FCC Class II Permissive Change Request Letter

RE: FCC Permissive II Change Request for Company: Guangdong Wangjia Intelligent Robot Co., Ltd.
FCC ID: 2AVYJ-J050A

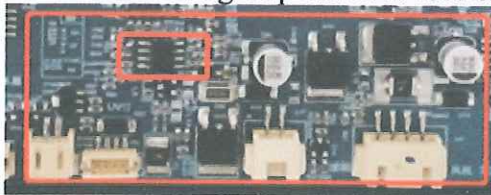
Remove the following gyroscope module, which functions to control EUT walking speed and Angle.

The added vertical 4P terminal and 2P seat have the same function, both are used for UVC-LED power supply, only one more UVC-LED is supported.

Original PCB

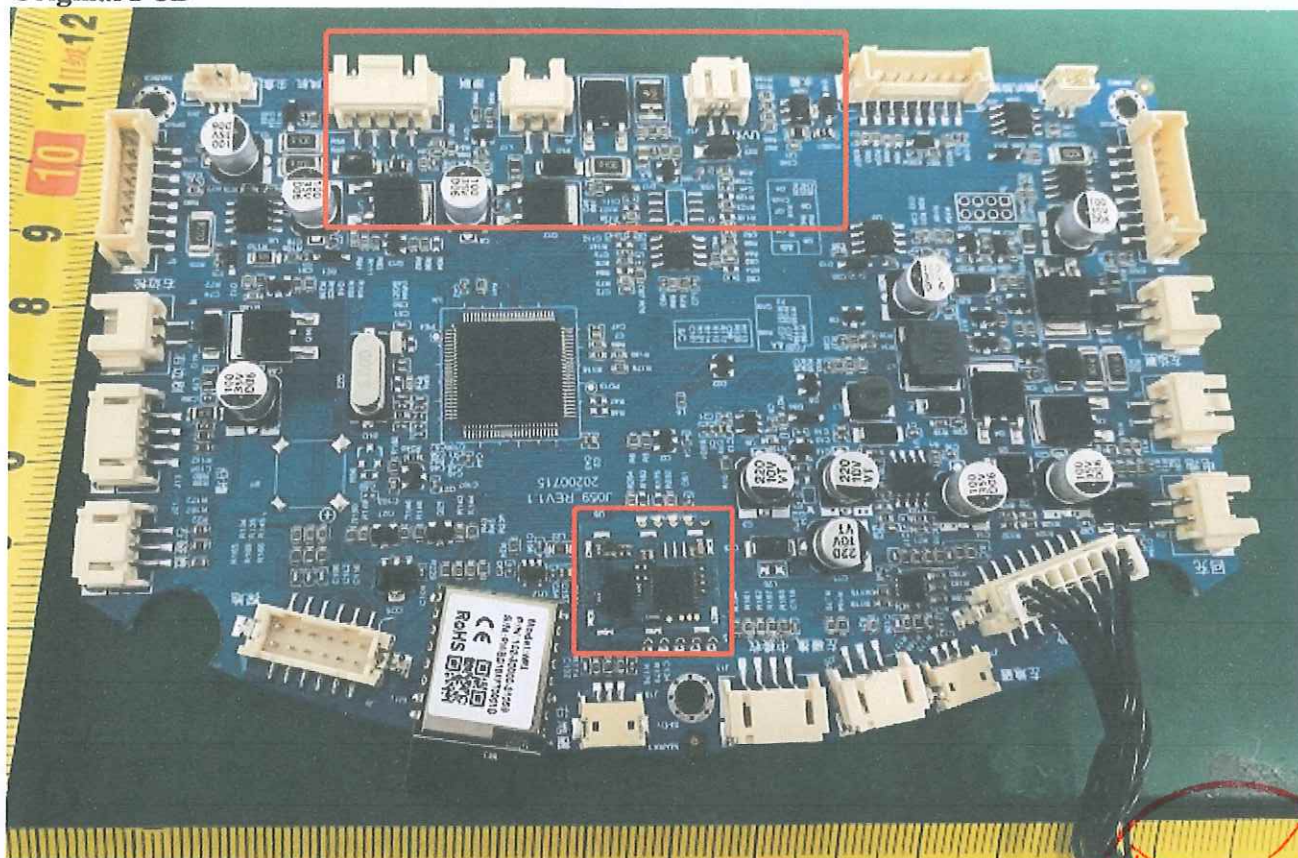
The PCB changes are as follows:

Add the following chip which is used to record the wheel speed.
